Access Compliance Report

Public Rights-of-Way

Intersection ID: 29172	Main Street: BOXELDER_LN	Cross Street: WHITEBARK_CT	Location: S
ADA ID: E50E8A2E09CC	Ramp Type: PerpDiag	Initial Pass/Fail: Fail	Overall Compliance: No
			Severity Score: 18.75

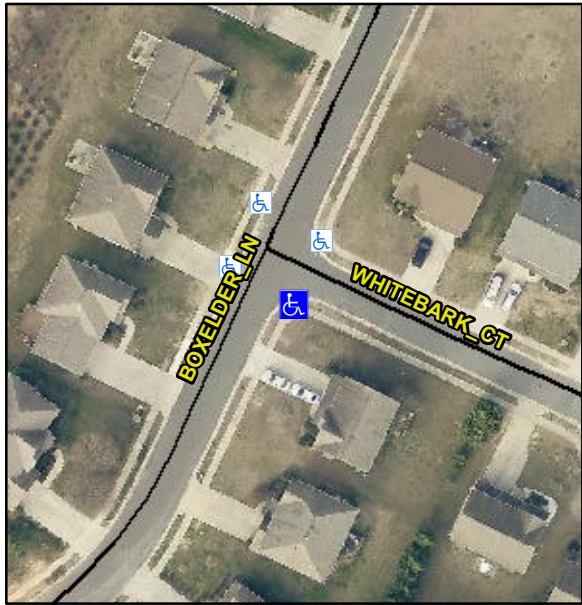
Codes/Mitigation Info/Possible Solution			Field Measurements/Component Compliance					
	Possible Solutions:		Compliance	Description	Data	Compliance	Description	Data
	Remove & Replace Curb Ramp With Two New Directional Ramps or Equivalent.		N/A	Ramp Length (in)	45.5	Yes	Ramp Slope (%)	7.5
			No	Ramp Width (in)	35.0	No	Ramp XSlope (%)	2.9
			N/A	Flare Type LT	N/A	N/A	Flare Type RT	N/A
			N/A	Flare Slope LT (%)	N/A	N/A	Flare Slope RT (%)	N/A
			N/A	Flare Traversable LT?	N/A	N/A	Flare Traversable RT?	N/A
			N/A	Landing Length (in)	N/A	N/A	DWS Provided?	N/A
			N/A	Landing Width (in)	N/A	N/A	DWS Contrast?	N/A
			N/A	Landing Slope (%)	N/A	N/A	DWS Length (in)	N/A
			N/A	Landing X Slope (%)	N/A	N/A	DWS Full Width?	N/A
Surveyor Notes:		N/A	N/A	Landing Curb? (Y/N)	N/A	N/A	DWS Offset (in)	N/A
PROW/ADA:		Not Found, R304.5.1, R304.5.3	N/A	Shared Landing?	N/A			
			N/A	Gutter Ponding?	N/A	N/A	Gutter Slope (%)	N/A
			N/A	Gutter Lip Ht (in)	N/A	N/A	Gutter X Slope (%)	N/A

N/A	Painted X Walk1?	No	N/A	Painted X Walk2?	No
				X Walk 1 Direction	To NE		X Walk 2 Direction	To NW
			N/A	X Walk 1 Width (in)	N/A	N/A	X Walk 2 Width (in)	N/A
				X Walk 1 Slope (%)	0.2		X Walk 2 Slope (%)	5.5
				X Walk 1 X Slope (%)	1.8		X Walk 2 X Slope (%)	0.8
			N/A	Ramp inside XWalk1?	N/A	N/A	Ramp inside XWalk2?	N/A
				Road Slope (%)	2.6	N/A	Clear Space?	N/A
				Road X Slope (%)	2.5	N/A	Clear Space to XWalk (in)	N/A
			N/A	Any Obstructions?	N/A	N/A	Storm Grate/Utility Hazard?	N/A
				Obstruction Type			Storm Grate/Utility Type	
					N/A			N/A
						Yes	Surface Condition? (G/P)	Good
Total Cost:		\$ 3200.00
